Case No. 18-1732-EL-REN

Gregory and Michele Paulin

Staff Interrogatories – Initial Set

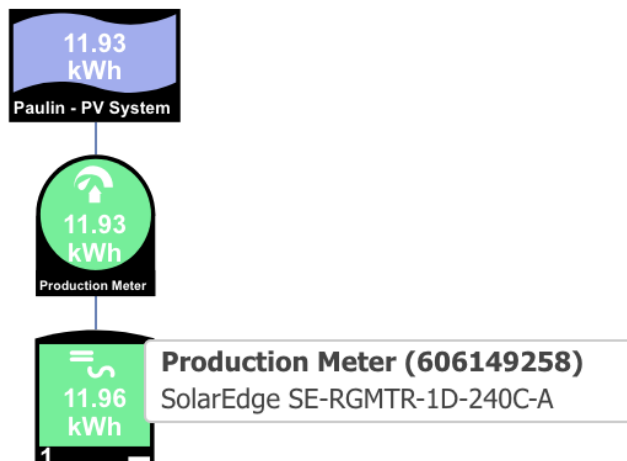
In section N.1 you state that meter manufacturer is Solar Edge type SE76000 A-US. The specification sheet of the SE7600 states that utility grade monitoring is "optional." Does this inverter have the revenue grade option? If so, please provide proof to this extent. If not, how will the facility meet the utility grade meter requirement?

The inverter is integrated with a revenue grade meter, as demonstrated in the photos below. The photos display a layout of the inverter & revenue grade meter as well as the inverter reading. The inverter screen will only read “Production Meter” on SolarEdge inverters that have the revenue grade meters installed.

Production Meter
Status: <OK>
Power[W]: 0.0
Energy[KWh]: 273.782
